**PUBLIC UTILITY COMMISSION OF OREGON  
STAFF REPORT  
PUBLIC MEETING DATE: FEBRUARY 20, 2024**

SUBJECT: PACIFICORP:  
Docket No. LC 82  
Acknowledgement of 2023 Integrated Resource Plan and Clean Energy  
Plan.

LC 82 Attachment A,  
Staff Redacted LC 82 Round 2 Comments

Figure 1. Difference in Installed Cumulative Capacity Between 2023 IRP Preferred Portfolio and Current Reality

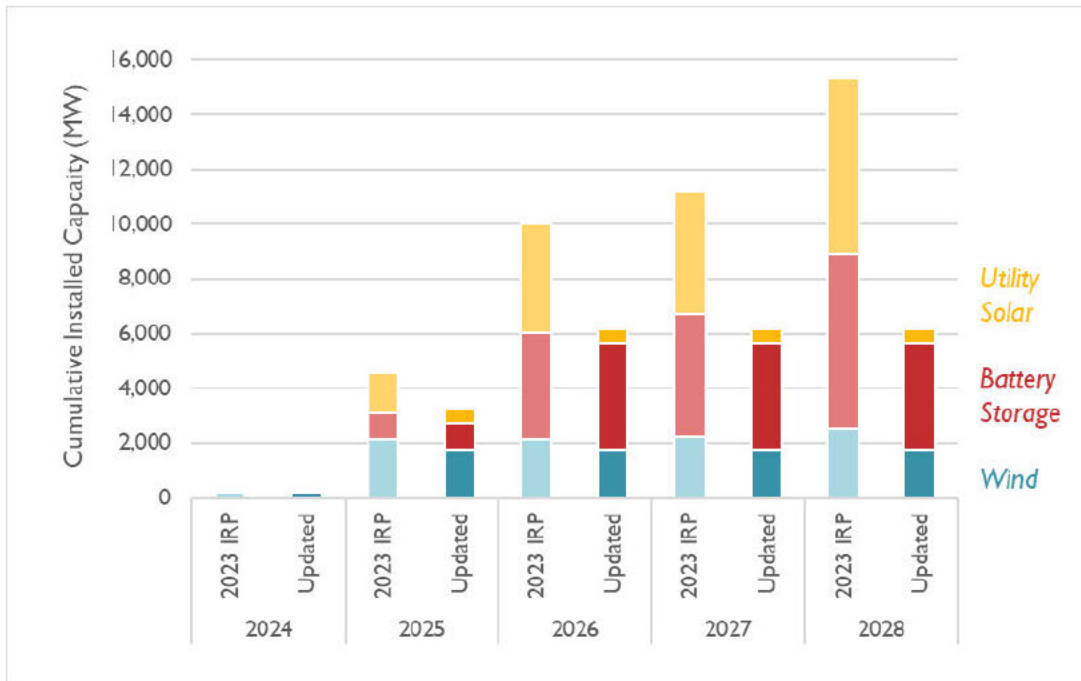
Given that the Preferred Portfolio included 2,531 MW of wind, 6,383 MW of solar, and 6,411 MW of battery capacity on the system by 2028, the impact of suspending a near-term RFP puts these builds at risk. In response to discovery, PacifiCorp confirmed that it is unable to procure the amount of wind and solar included in the Preferred Portfolio in years leading up to 2028.<sup>17</sup> Table 2 summarizes the difference in installed capacity between the Preferred Portfolio and the additions that may actually occur if PacifiCorp is unable to procure any additional new renewables, other than the bilateral storage mentioned above.

The figure below demonstrates the impact that this delayed procurement could have on renewable resource builds over the next five years. The “2023 IRP” chart series on the left represents the data as presented in the Preferred Portfolio. The “Updated” chart series on the right represents capacity that PacifiCorp has currently indicated it can procure based on the 2020AS RFP and bilateral storage contracts. Solar is the resource that is most at risk due to the 2022AS RFP suspension, as the 2020AS RFP did not result in a large number of solar additions and PacifiCorp has not indicated any alternative procurement processes for solar.

Figure 2. Reproduction of Figure 9.60 in IRP, with and without 2022AS RFP Suspension Impacts

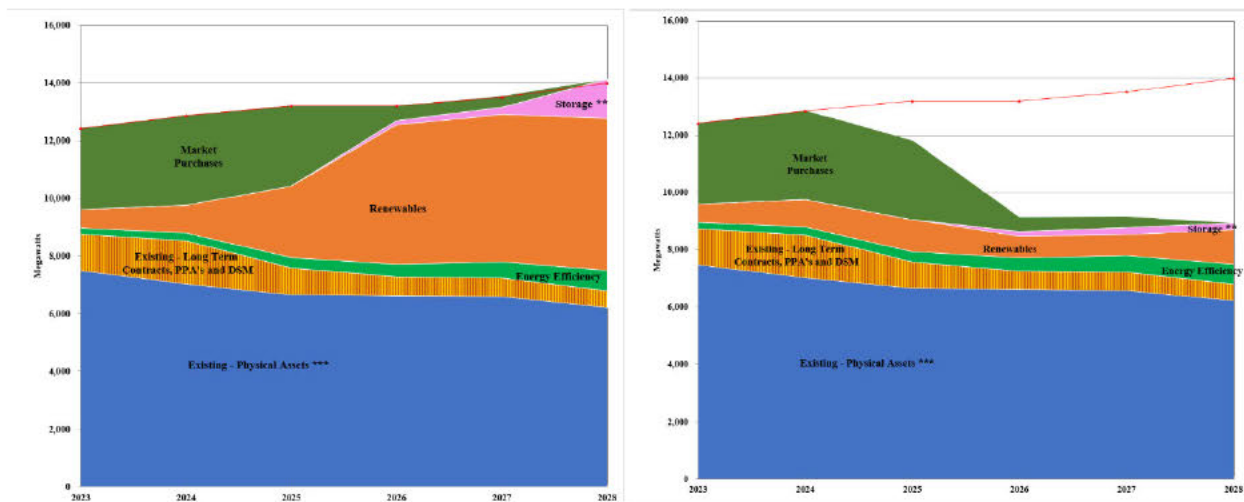
This delay will also have a significant impact on the generation mix of the system. Figure 9.60 in the IRP shows the projected generation by resource type for the Preferred Portfolio. Over the next five years, PacifiCorp’s Preferred Portfolio relied heavily on market purchases (also referred to as front office transactions or FOTs) and existing resources in the near-term while transitioning to rely more and more on new renewable resources. The left side of the figure below is a reproduction of Figure 9.60 as published in the IRP for years through 2028. The right side of the figure below demonstrates what the generation mix could look like if PacifiCorp does not procure new renewables and instead has a capacity mix that resembles the “Updated” chart series in Figure 9 above.

Without the guarantee of additional solar, storage, and wind resources coming online over the next few years, PacifiCorp may end up relying more heavily on FOTs or delaying thermal resource retirements relative to the Preferred Portfolio. This could lead to decarbonization risks, which the Company has not adequately addressed in the current IRP.

**Staff Recommendation 1.** Do not acknowledge the IRP action plan elements 2b and 2c, the IRP's preferred portfolio, or the IRP's long-term plan.

**Staff Recommendation 2.** Direct PacifiCorp to seek acknowledgement of a revised Preferred Portfolio and Action Plan in the planned April 2024 IRP Update.

**Staff Recommendation 3.** Do not acknowledge the LC 82 CEP and direct PacifiCorp to revise and resubmit the CEP with its April 2024 IRP Update.

Figure 8: 3Comparison of Forecasted v. Actual Coal Use as Percent of Generation

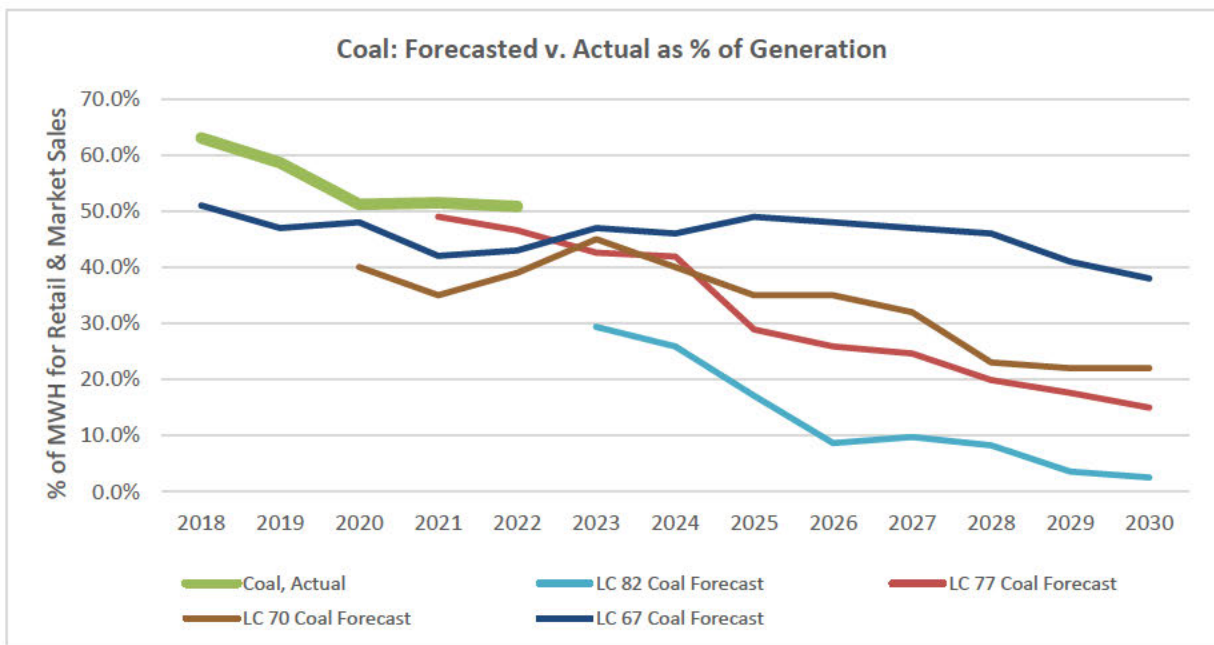
Staff conducted a brief analysis forecasted to actuals in an attempt to substantiate CUB’s comments regarding the disconnect between planning that uses a carbon price and actual coal operations.

Staff’s simple analysis would seem to corroborate CUB’s concerns regarding the realism of PacifiCorp’s modeled coal dispatch in the IRP. Staff raised a similar concern in UM 2225 in discussing the role of

**Figure 9: Mid-term DRI Hours and Magnitude for the Western Interconnection**

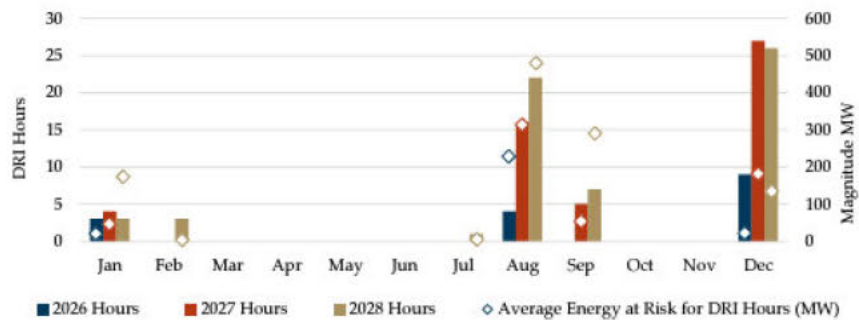
Notably, PacifiCorp’s IRP relies on 944 MW of summer market purchases in 2027 and 493 MW in 2028.<sup>134</sup> Given WECC’s showing of regional resource adequacy risk during August in those years (red bars in Figure 4 above), the expectation of nearly 1 GW of market energy being available for purchase during summer peak hours seems potentially risky. Further, PacifiCorp has suspended the 2022AS RFP that would have brought resources online from 2025 through 2027, further increasing the region’s resource adequacy risk.
